## Product Change Notification / RMES-02XQHS264

CCB 3658.006 Final Notice: Qualification of MPHL as an additional final test site for selected ATSAML21G1xB device family available in 48L VQFN (7x7x0.9mm) package.

**CCB 3658.006**  
**Pre and Post Change Summary**  
**PCN #: RMES-02XQHS264**

# Pre and Post Change Summary

# Pre and Post Change Summary – Cover Tape

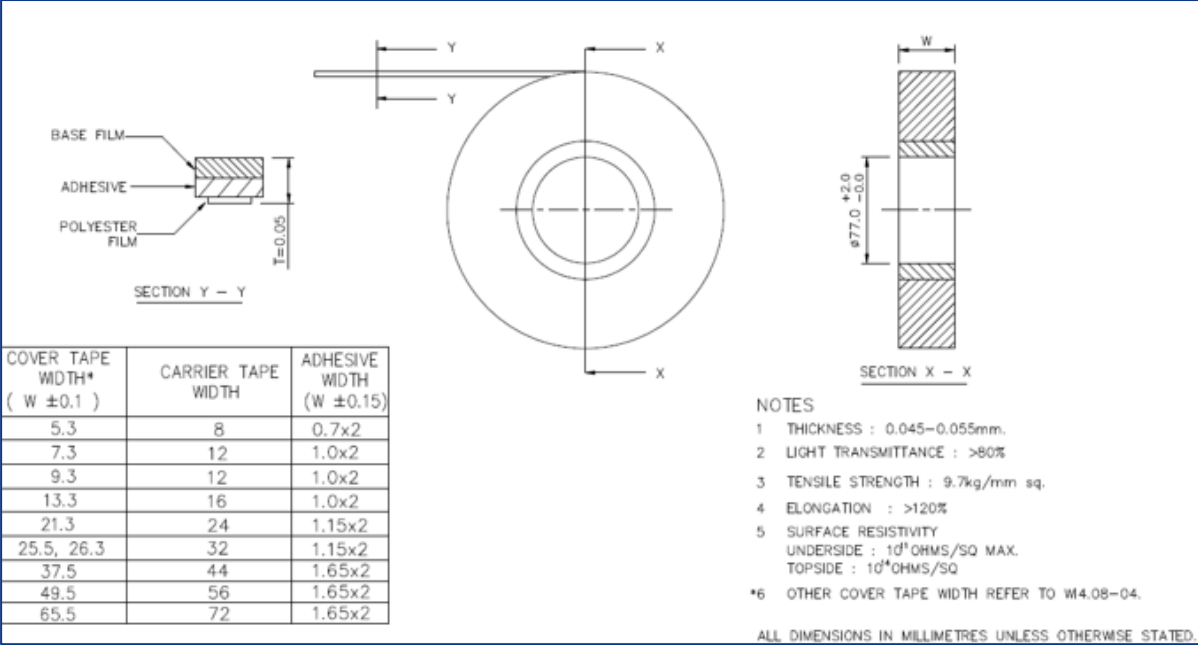
Cover tape color	Width $\pm 0.1$ (mm)	Thickness $\pm 0.005$ (mm)	Sealing Methodology
Clear	13.3 mm	0.053+/-0.005	Heat Seal

Cover tape color	Width $\pm 0.1$ (mm)	Thickness $\pm 0.005$ (mm)	Sealing Methodology
Clear	13.3 mm	0.050	Pressure Seal Activated

# Pre and Post Change Summary – Plastic Reel

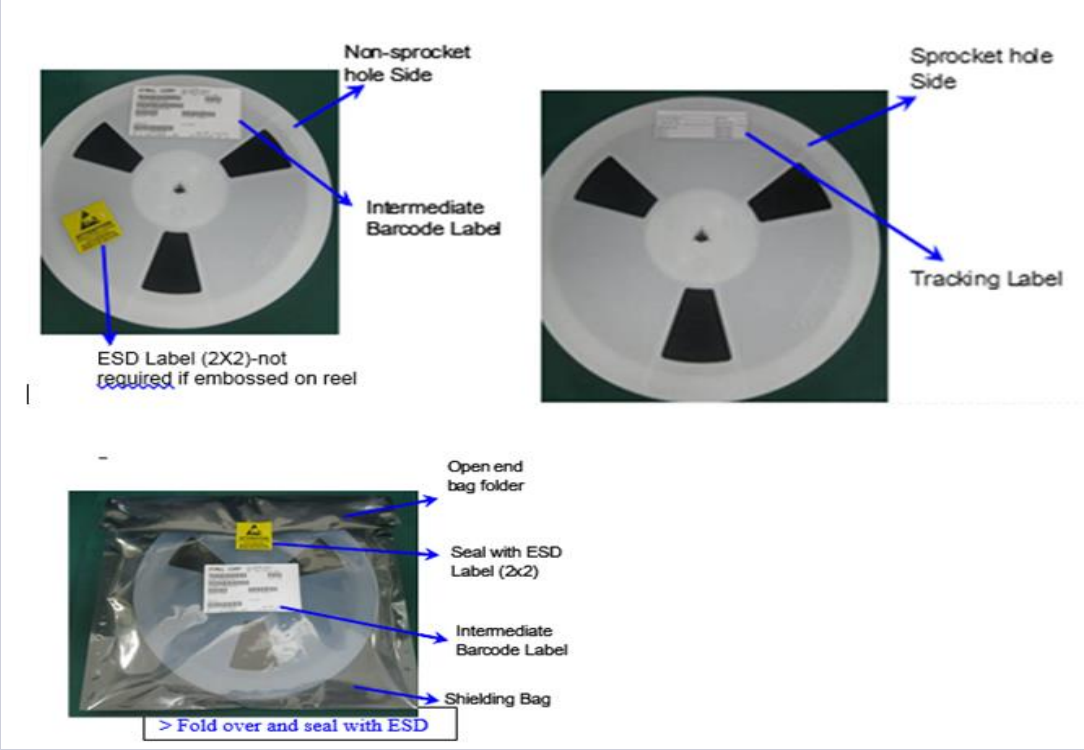
Reel Color	Reel diameter (mm)	Hub (mm)	W1 +0.3 /-0	W2 (mm) Max
White	330	102	16.8	22.2

Reel Color	Reel diameter (mm)	Hub (mm)	W1 +0.3 /-0	W2 (mm) Max
White	330	100	17.5	21.5

**January 30, 2023:** Re-issued final notification. Corrected ASE9 plastic reel W1 and W2 in Pre and Post change summary.
